Re: Application for Comprehensive Permit – School Street, Manchester

As you know, this firm represents the Manchester Essex Conservation Trust ("MECT") in the above-referenced matter. We understand that the Project's wastewater arrangements will be the topic of discussion at the Board's upcoming hearing this evening. We would like to take this opportunity to provide our initial comments on this critical design issue.

Figure 1

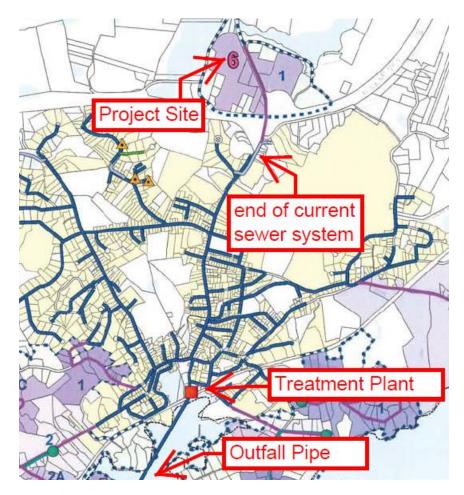
Until about a month ago, the Project's wastewater was going to be treated and discharged on-site, through a state-permitted wastewater treatment facility ("WWTF"). On March 25, 2022, nearly five months into the Board's public hearing on this application, the Applicant did an about-face, abandoning the on-site WWTF design and instead proposing a connection to the Town's sewer system. There are no sewers in School Street north of Route 128. To make this connection, the Applicant is proposing to *extend* the Town's sewer system, from a point on School Street "south of Hidden Ledge Road," according to Site Plan sheet C-104.¹

¹ An annotated excerpt from the existing sewer service area map, Figure VI-1 from the Town's 2016 Comprehensive Wastewater Management Plan, is reproduced below as Figure 1.
